ALERT SERVICE BULLETIN

UH-1H-17-19

MODEL AFFECTED: UH-1H

SUBJECT: MAGNETIC BRAKE ASSEMBLY 204-001-376-003
INSPECTION AND REPAIR OF.

Figure 1. Magnetic brake assembly.

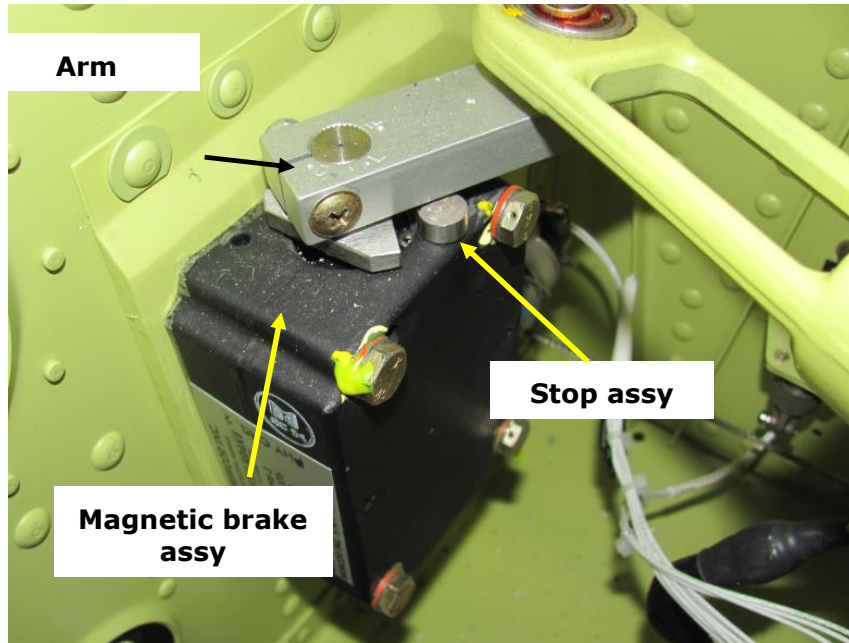
1. Prepare the helicopter for maintenance.
2. Gain access to the cyclic and anti-torque magnetic brake assembly.
3. Perform a detailed visual inspection of the stop assemblies (Figures 1 and 2). Figures 3 and 4 show a stop assembly found debonded.

Figure 3. Stop assembly with debonded shaft.

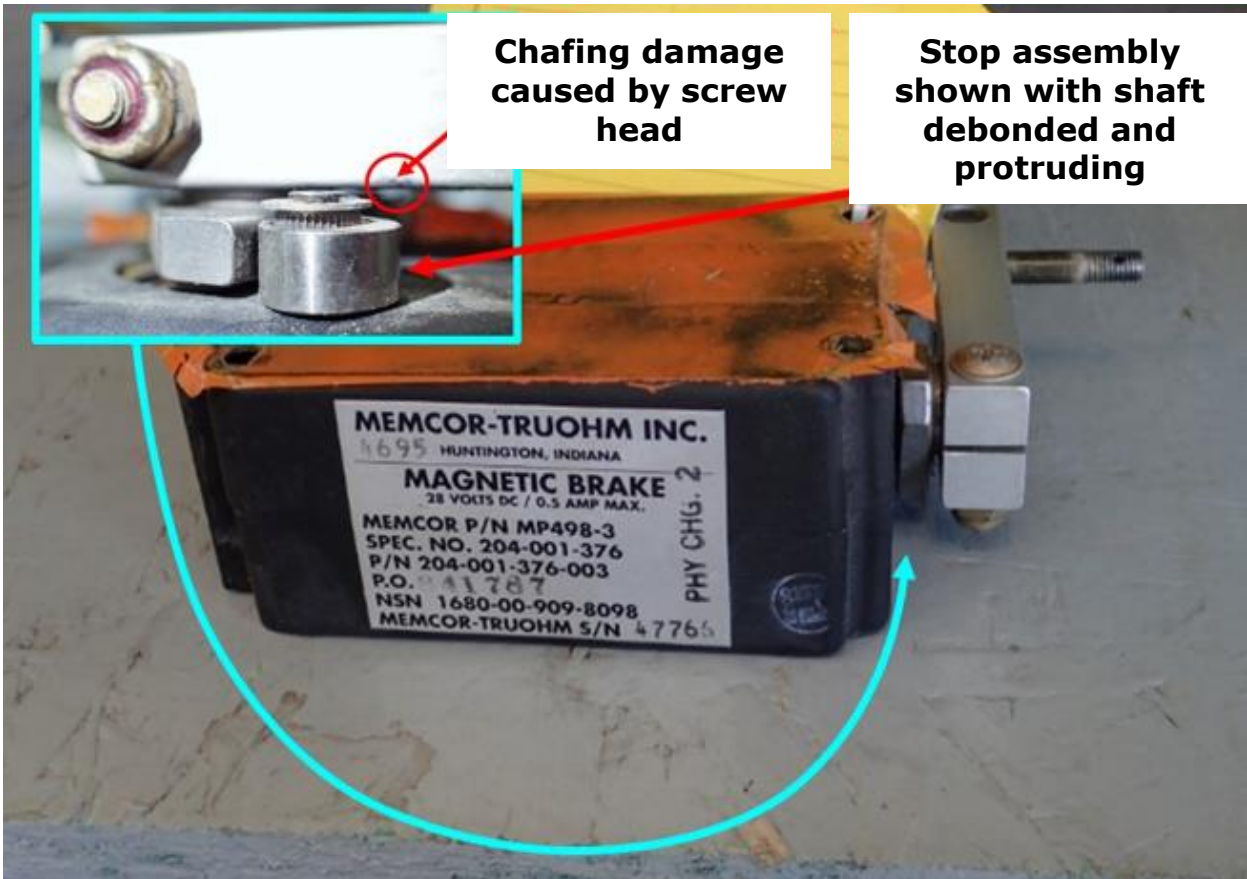
4. Pull on the stop assembly by hand to verify if the stop shaft is debonded from the housing assembly. If the shaft shows evidence of debonding, inspect the lower side of the arm for possible chafing damage. Repair allowable damage and then accomplish Part II. The maximum allowable mechanical damage is 0.030 inch. Repair allowable chafing damage as follows:

- a. Using 220 grit of finer abrasive cloth or aluminum oxide paper, polish out mechanical damage found within the allowable 0.030 inch
 - b. Apply aluminum alloy chemical film treatment to the repaired area (BHT-ALL-SPM).

Figure 5. Adjustable Stop Assembly Installation

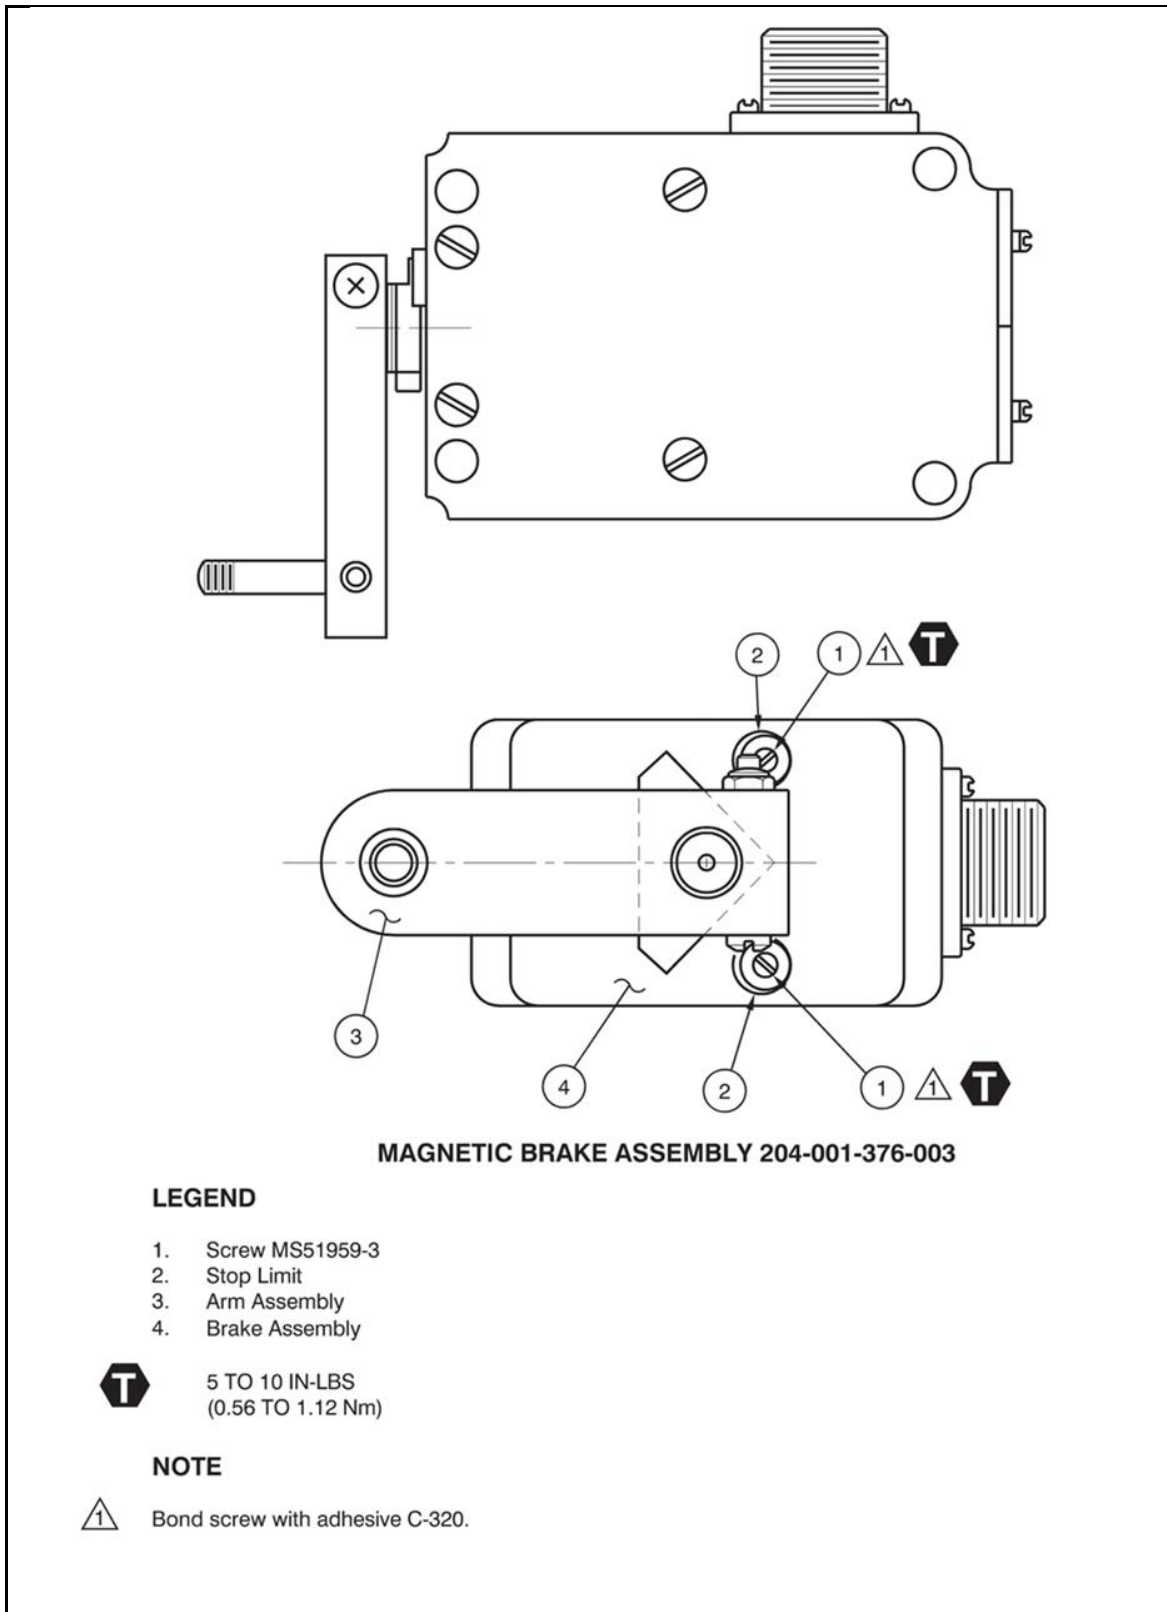
10. Verify/adjust stop limits to achieve the arm assembly travel. If the screw is removed from the shaft, reinstall with adhesive (C-320) and torque to 5-10in-lb. (Figures 5 and 6)

Figure 6. Stop Assembly Travel

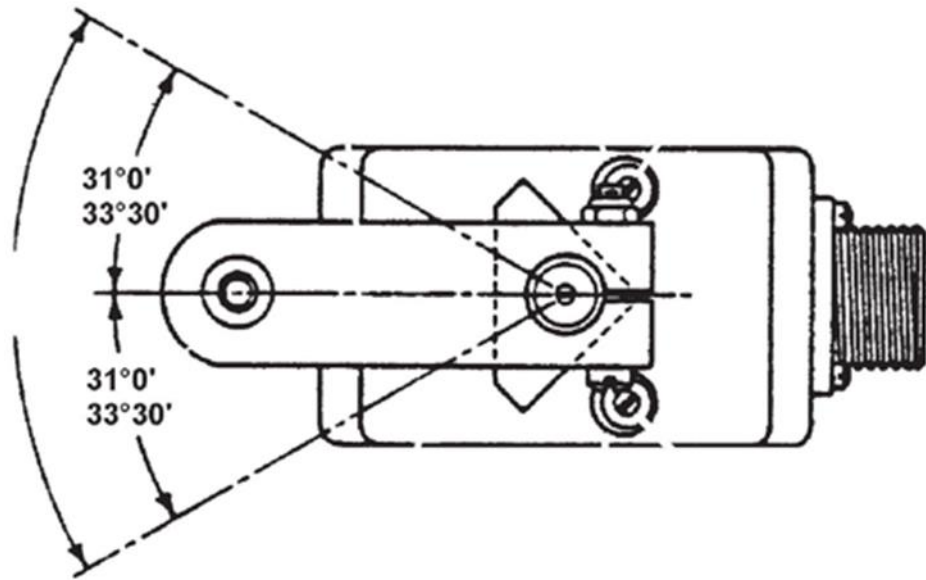
Regardless of arm letter indexing, total travel of the arm in relation to the stops is the same. Arm position shown would be for a cyclic controls installation.
